**STAFF REPORT
DEVELOPMENT COMMISSION
ZONING MEETING
CITY OF COLUMBUS, OHIO
FEBRUARY 12, 2015**

- 3. APPLICATION:** **Z14-010 (14335-00000-00134)**
Location: **4956 AVERY ROAD (43016)**, being 101.77± acres located on the east side of Avery Road, 2,935± feet north of Hayden Run Road (010-265649 plus 2 others).
Existing Zoning: R, Rural District.
Request: CPD, Commercial Planned Development and L-AR-1, Limited Apartment Residential Districts.
Proposed Use: Commercial and multi-unit residential development.
Applicant(s): DCR Commercial Development; c/o Laura MacGregor Comek; 300 East Broad Street, Suite 450; Columbus, OH 43215.
Property Owner(s): The Applicant.
Planner: Shannon Pine, 645-2208, spine@columbus.gov

Z14-010, 4956 Avery Road – Staff Review (January 12, 2015 Update)

CITY OF COLUMBUS
SITE PLAN
FOR
WHITE FAMILY FARM
AVERY ROAD
ZONING PLAN

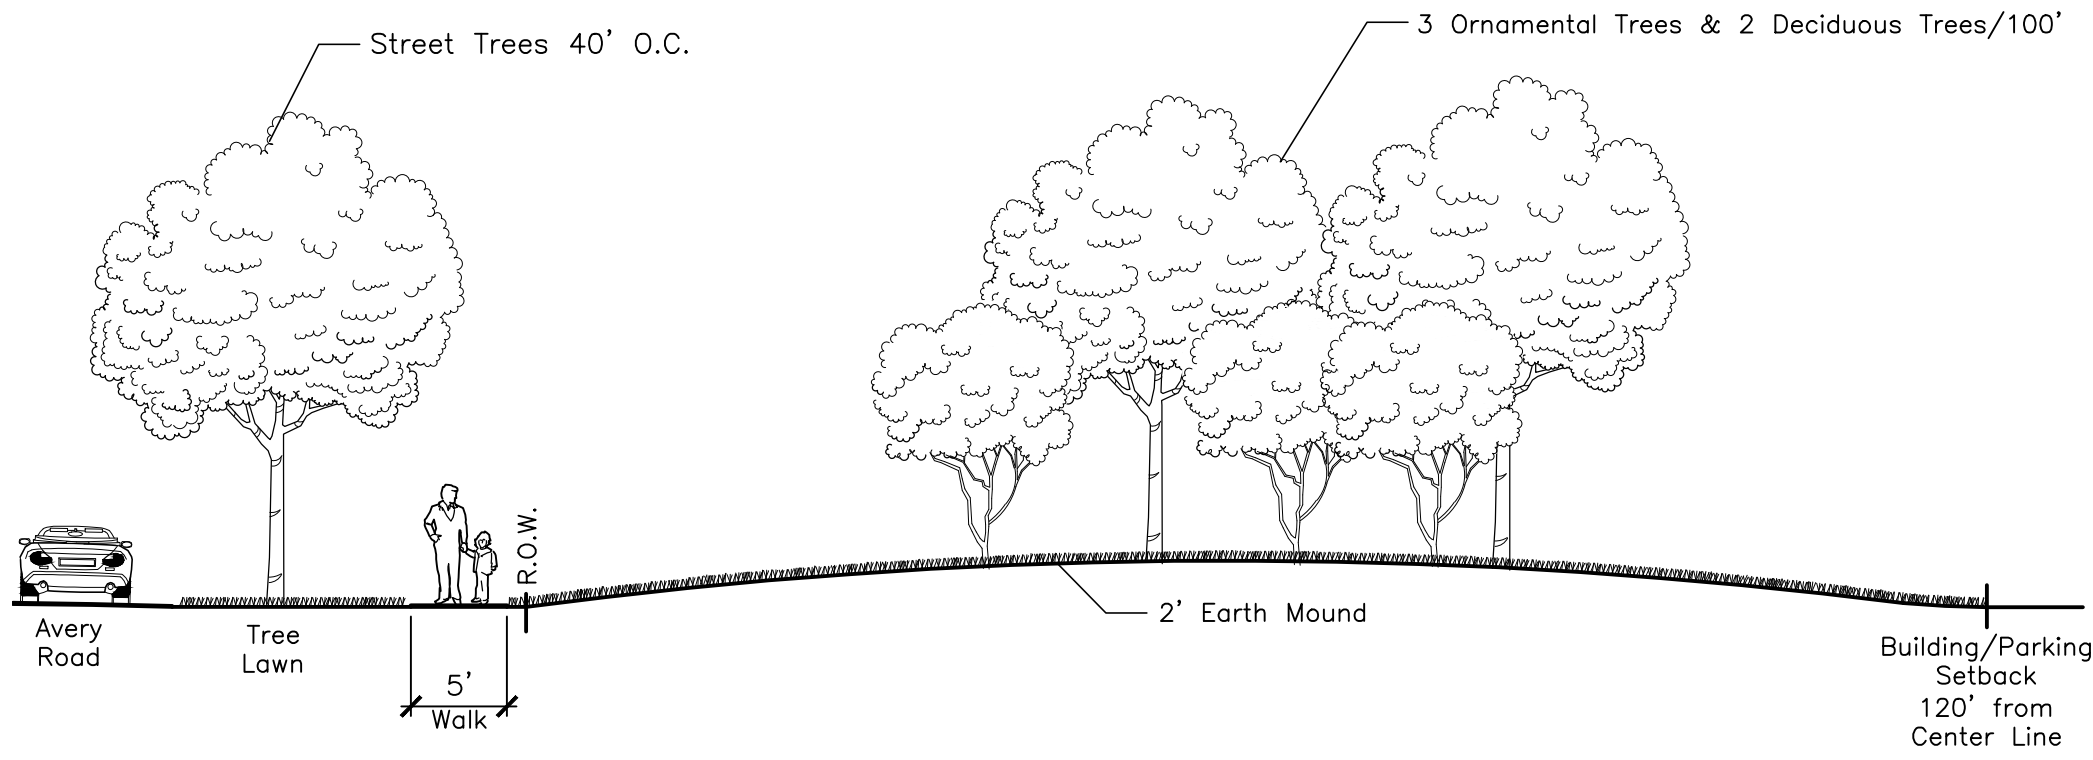
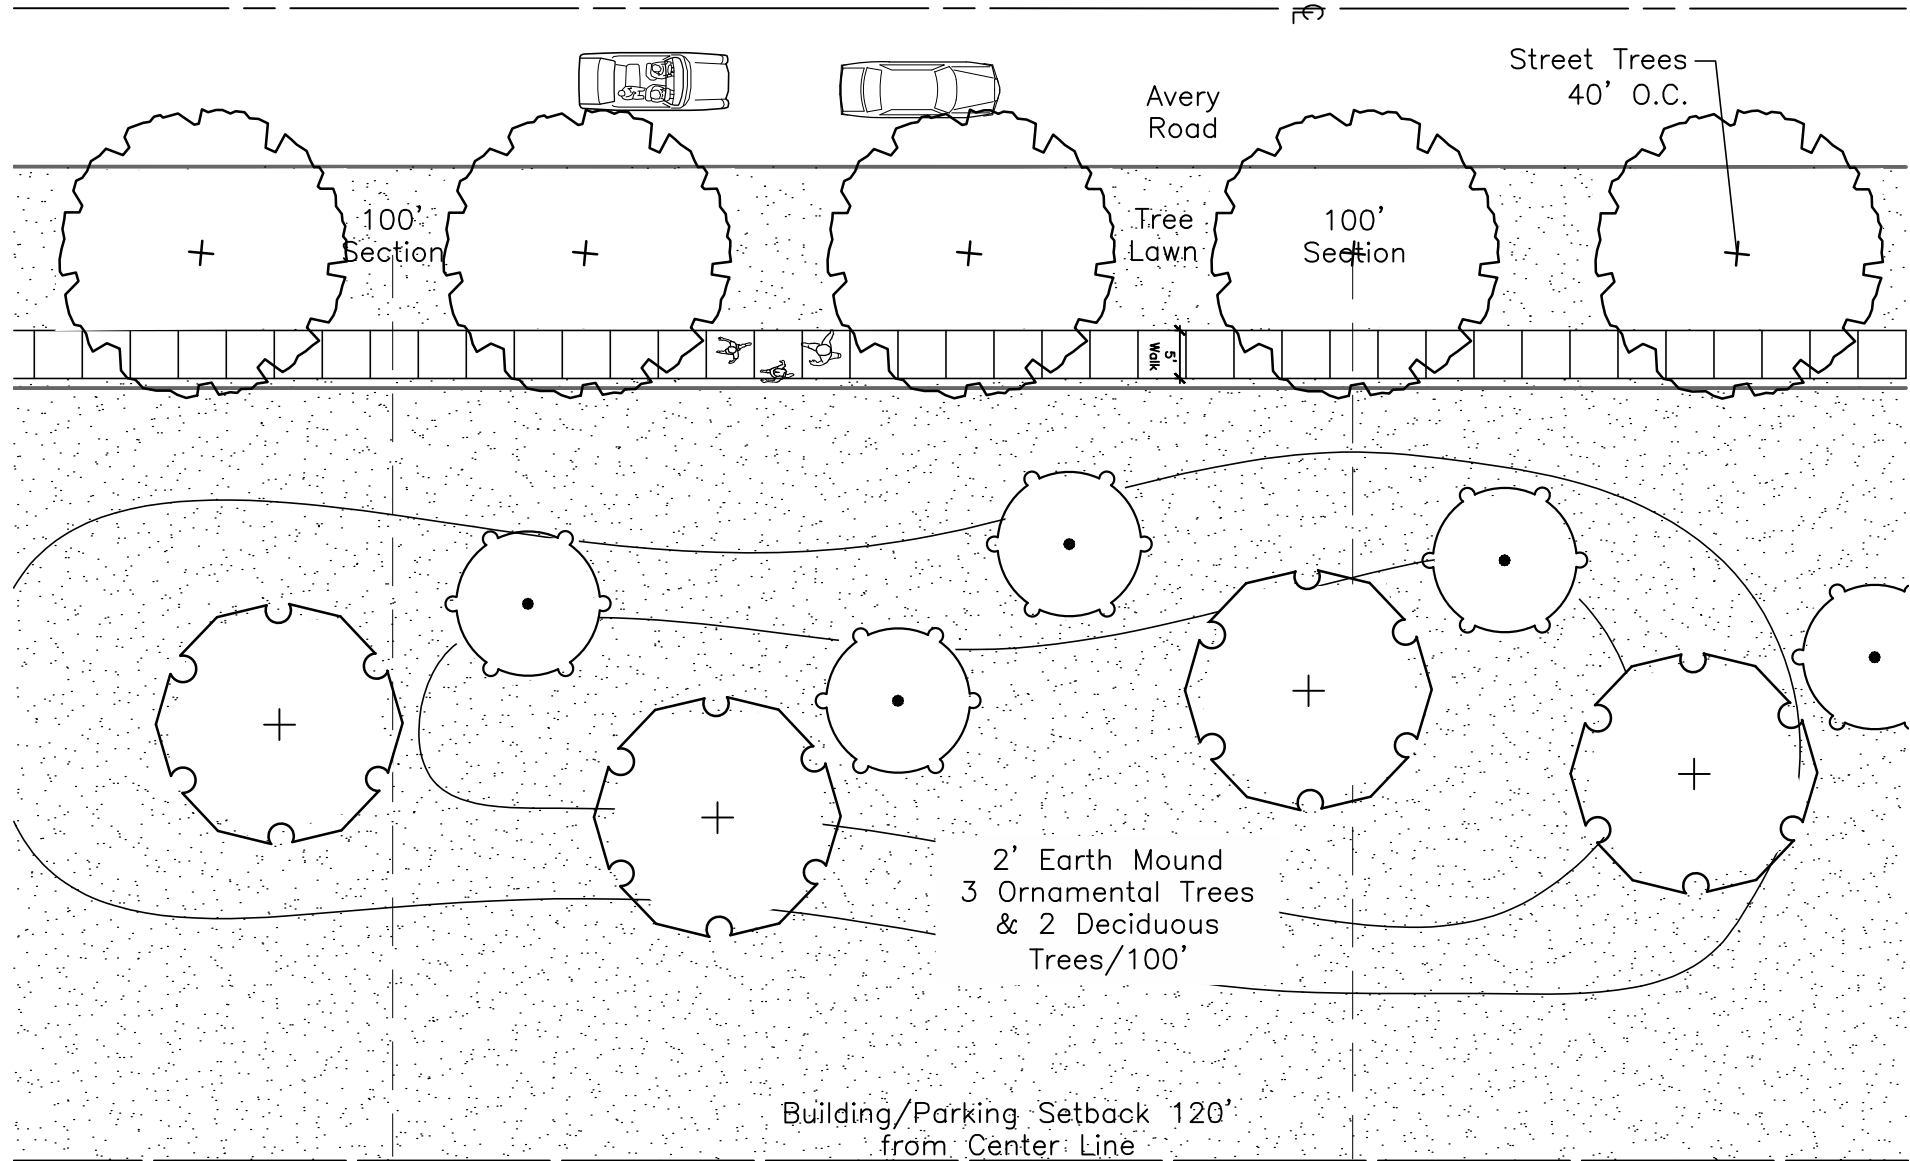
- Staff notes that only one vehicular connection is depicted between subareas 1 and 2, with an additional ped/bike connection. Given the plan's emphasis on connectivity and the scale/nature of development, staff considers this inadequate.

- The updated subarea map and development text commit to an approximately 2 acre neighborhood green with a location to be determined. While this is a positive change, it lacks clarity regarding location and relationship to broader subarea.

- Staff requests clarification regarding permissible uses within the proposed green, potential parkland dedication area and Hayden Run buffer. Will stormwater management or other improvements be permitted? Staff notes a roughly 1.5 acre area of mature trees at the southeast corner of subarea 2. Will this be preserved?

- Some form of interior site plan depicting primary circulation patterns, open space, general building envelopes, relationship to adjacent residential, is needed etc.
- Greater setback along Avery Road and Hayden Crossing (proposal is 15' parking in each case)
- Commitment to minimize parking between buildings and road frontages.
- Commitment not to back buildings to Avery/Hayden Crossing
- Eliminate 60' height district request.
